Board of Architectural Review

DATE: August 28, 2015
TO: Board of Architectural Review Chair and Members
THROUGH: Jason Sutphin, Community Development Division Chief JDS
FROM: Kelly O'Brien, AICP, BAR Liaison KO
SUBJECT: **Northern Virginia Autobody Façade Modifications**

1. Case Number: 15080019
2. Address: 3156 - 3160 Roanoke Street
3. Request: Approval for building façade modifications
4. Applicant: NoVA Autobody
5. Applicant's Representative: Trish McMaugh
6. Zoning: I-2, Industrial District, HCOD Highway
Corridor Overlay District

PROPOSED SOUTH ELEVATION

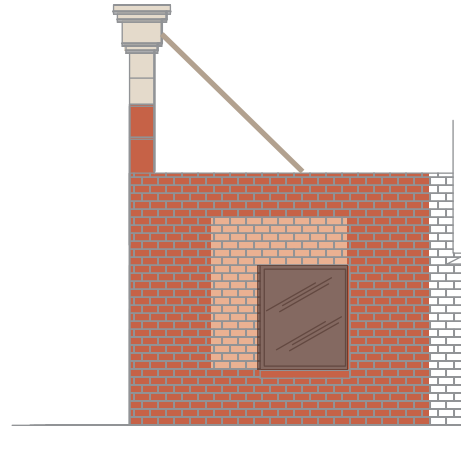
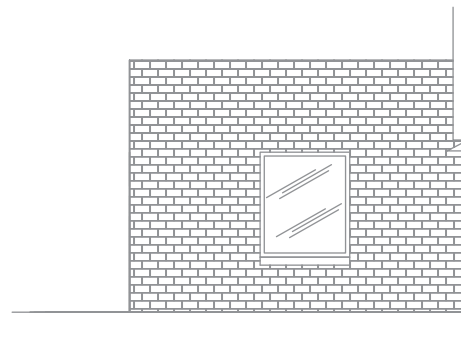
Conditions 4, 6 and 7 bolded above were not implemented as approved. The existing windows on the south façade were covered over and painted. The brick color paint does not extend the full length of the building and a beige rectangle was added to the south façade. The fence and gate with barbed wire have not been replaced.

Staff would have preferred the existing windows had remained as approved but recognizes that at least the openings are still there giving at least some relief to the building. The beige rectangle painted on the south façade does not make sense with the architecture of the building. Staff recommends the entire sides of the building to the point where they meet with other buildings be painted "Brick" as approved previously. The applicant has stated that the front fence and gate will be replaced after City Council approves installation of the same fence style along the frontage of 3159 Campbell. Staff does not feel bringing this site into conformance should be held up by another site. The two fences are not connected in any way.

The applicant’s submitted plans show the paint stopping approximately 15 feet from the front façade. Staff recommended to the applicant that the entire north and south facades be painted to match the stucco.

The applicant’s materials show a window to be painted over as it is not functional. The interior has been walled off. Staff recommended that the window remain unpainted. The similarly non-functioning door on the façade shall be painted to match the stucco colors previously listed.

1. The applicant shall secure all required permits prior to commencement of work.
2. The existing fence and gate shall be replaced with the black metal picket fence and gate proposed by the applicant.
3. The south and north elevations shall be painted “Brick” colored the entire length of both facades.
4. The white picket fence shall be removed from the rear of the 3156 Roanoke façade.

7. The window on the south elevation shall not be painted.

PROPOSED NORTH ELEVATION

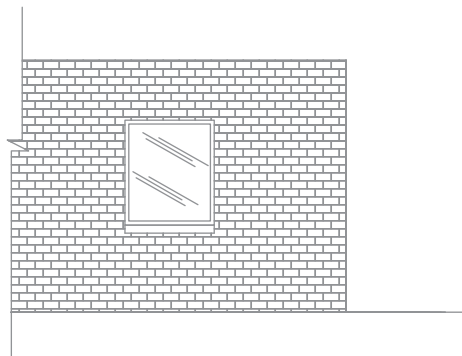
The plans also show the base of the parapet wrapping around only the south elevation. Staff recommends wrapping at least the base “Brick” color stucco around a portion of the north elevation to screen the parapet brackets.

5. The parapet base shall continue on the north elevation to screen the parapet bracket.
6. The south and north elevations shall be painted "Brick" colored to match the stucco on the entire length of both facades.

IRON WORLD

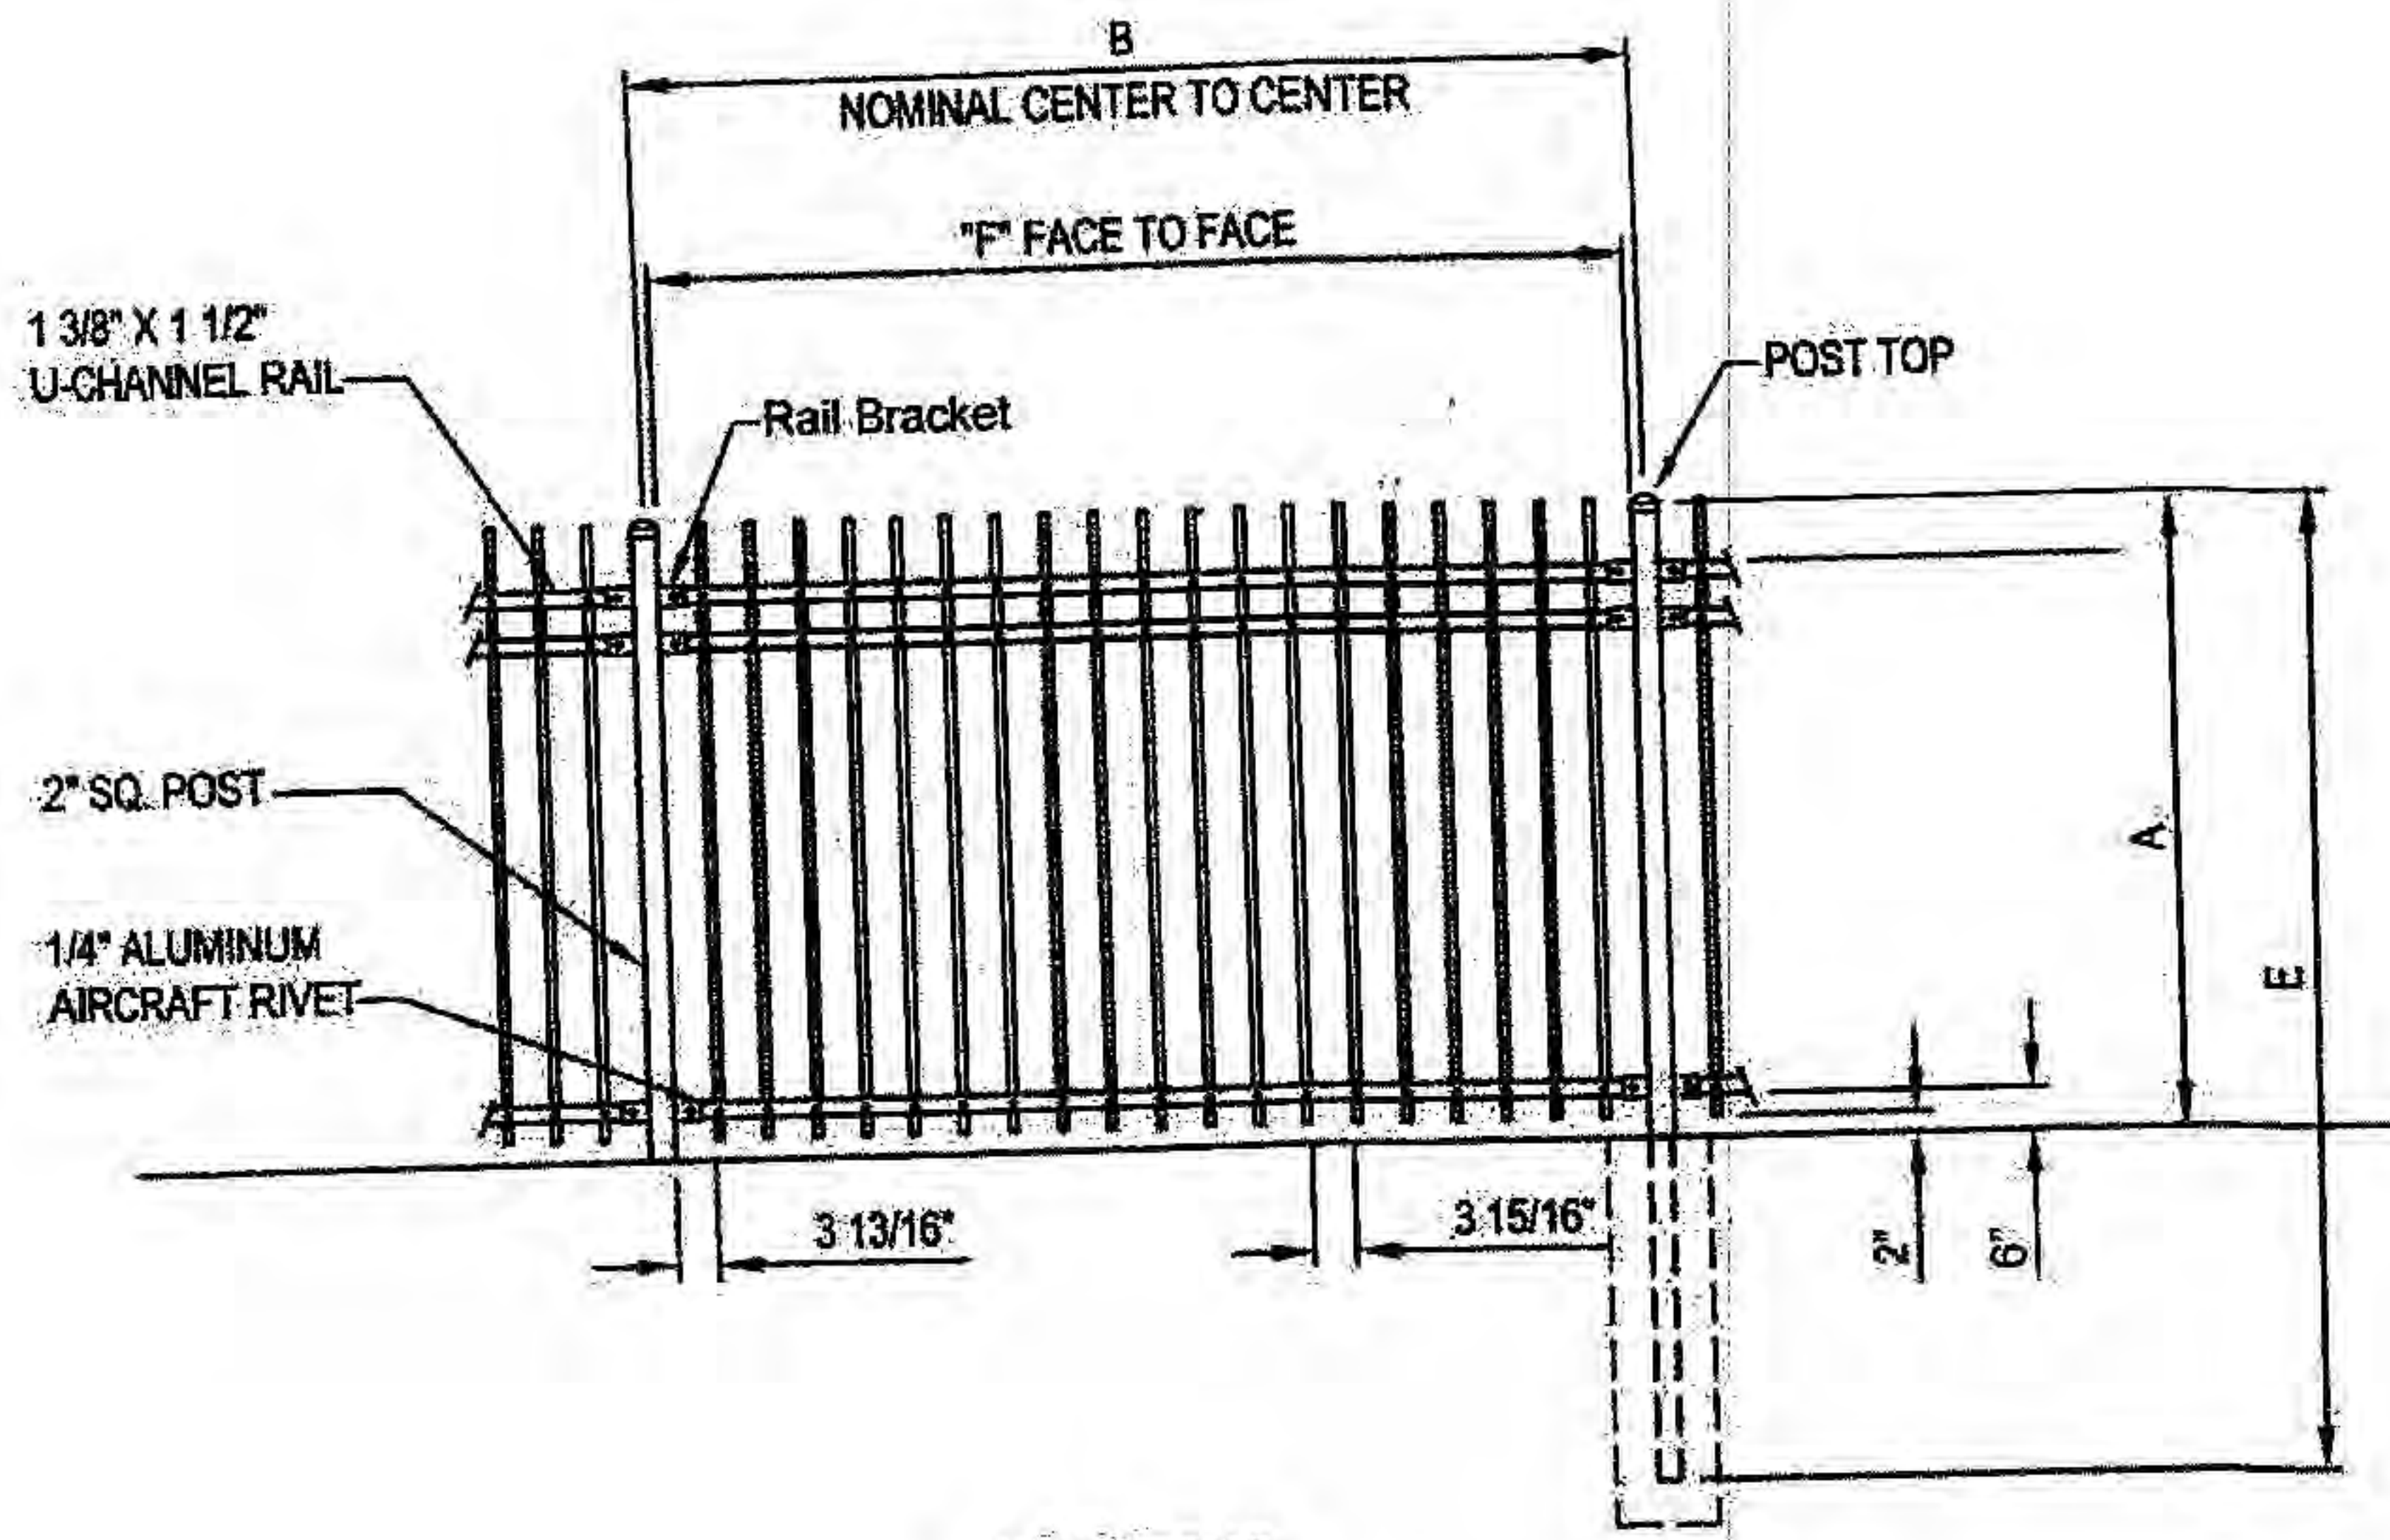
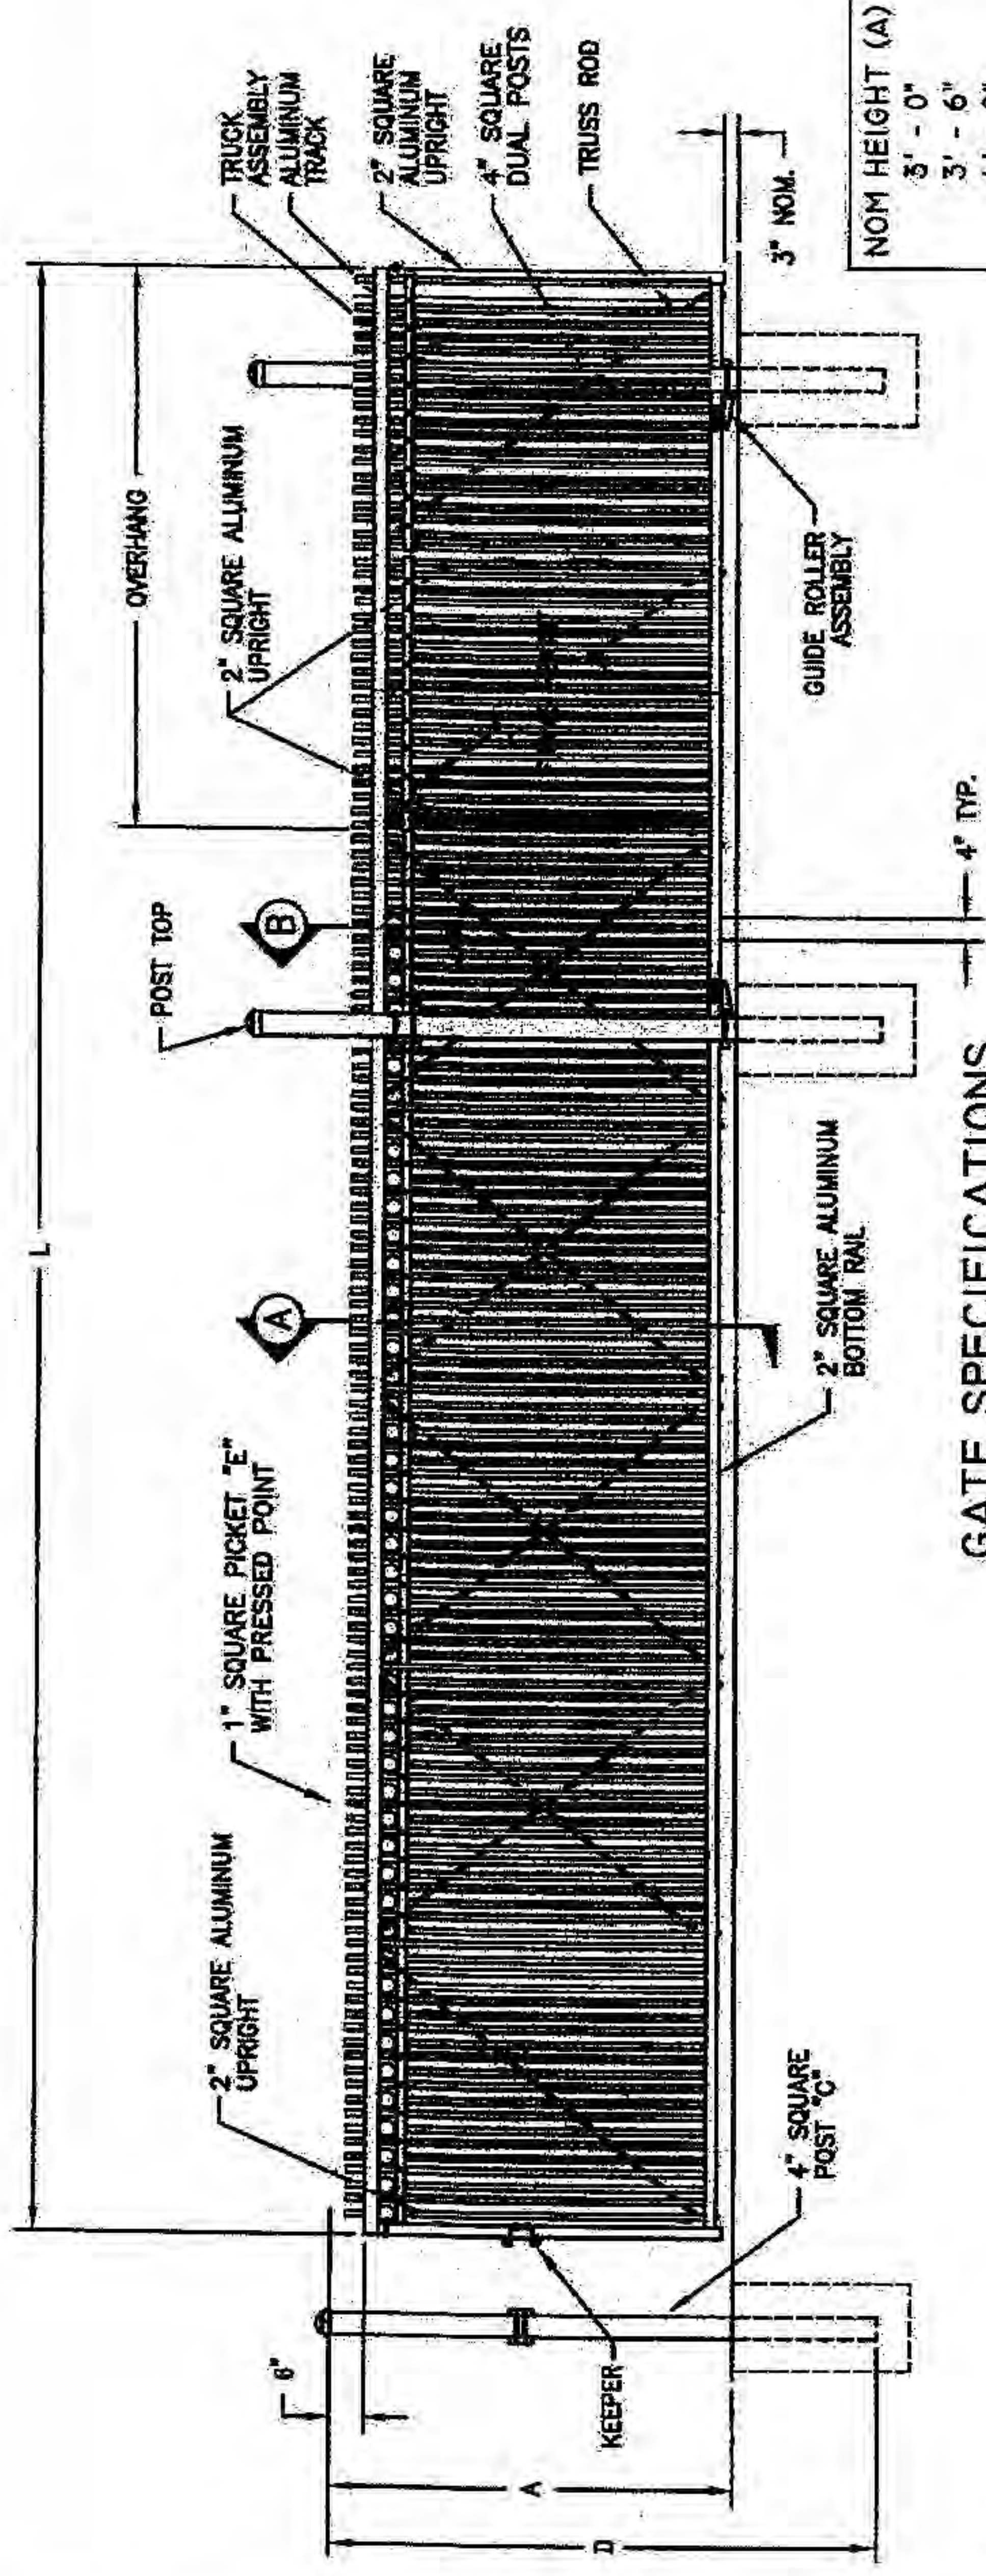
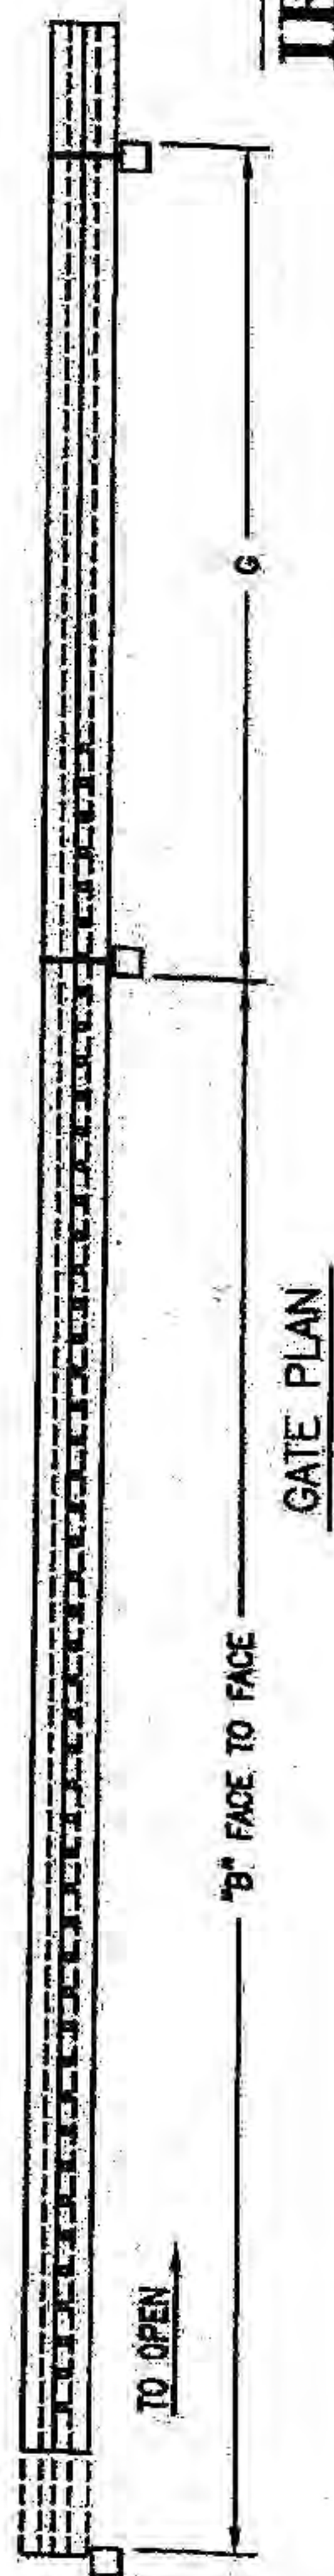
The site has an existing fence and gate with barbed wire. The applicant has agreed to replace the existing fence with Iron World metal picket fence and gate.

3. The applicant shall secure all required permits.
4. The existing fence and gate shall be replaced with the black metal picket fence and gate proposed by the applicant.
